**Re: Alberta Energy and Utilities Board ("Board") Application No. 1485517 (the "Application"); Alberta Electric System Operator ("AESO") Transmission Tariff for January 1, 2007 to December 31, 2007; Dual Use Customers ("DUC") Responses AESO and Intervener Information Requests regarding Exhibit 229 PSC issues**

**ALBERTA ENERGY AND UTILITIES BOARD**  
AESO 2007 Transmission Tariff Application - Phase I and Phase II  
APPLICATION 1485517  
Information Request No. 1 of the Alberta Electric System Operator (AESO)  
to the Dual Use Customers (DUC)

Ex. 229, Figure 10 Revised - Distribution of Bill Increases from AESO 2005 DTS Rate to DUC Proposed 2007 DTS Rate:

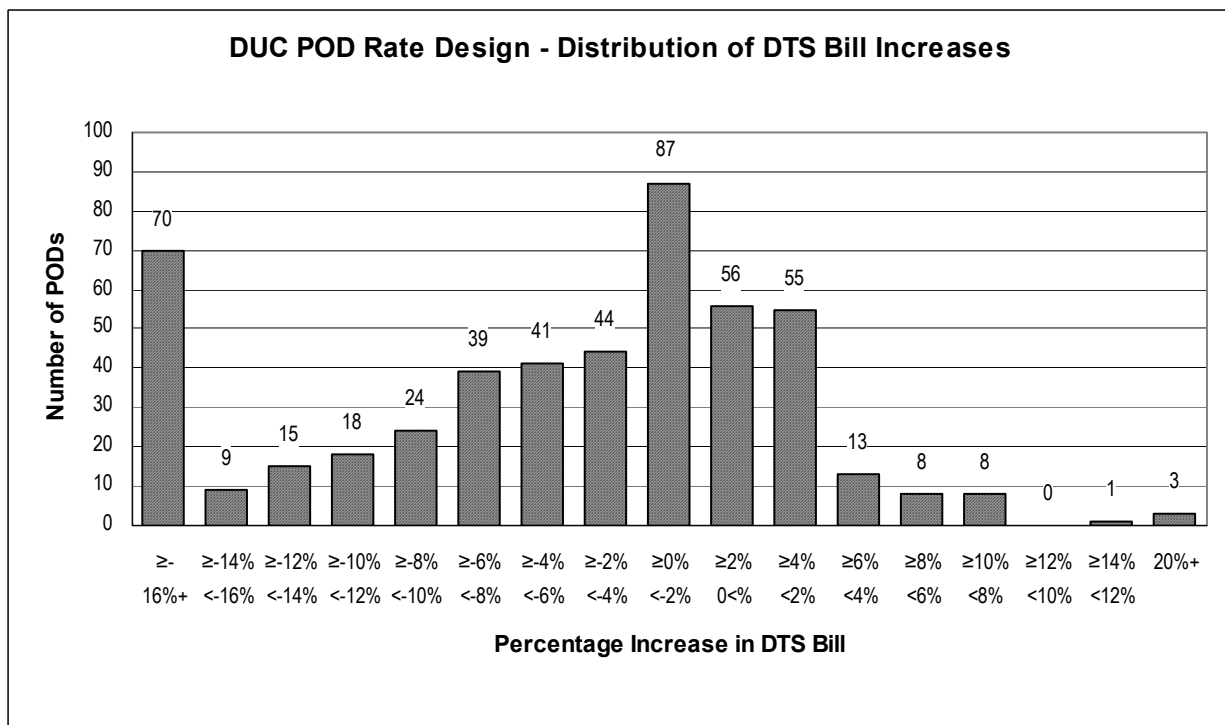
Reference: Figure 10, page 23. Table 5, page 24. Figure 11, page 24. Figure 13, page 27

Can the DUC please reproduce these figures and tables by comparing 2005 DTS rates to 2007 DTS rates?

The following provide the requested comparisons. These comparisons were derived using the DUC spreadsheets filed as Exhibits 230 and 231.
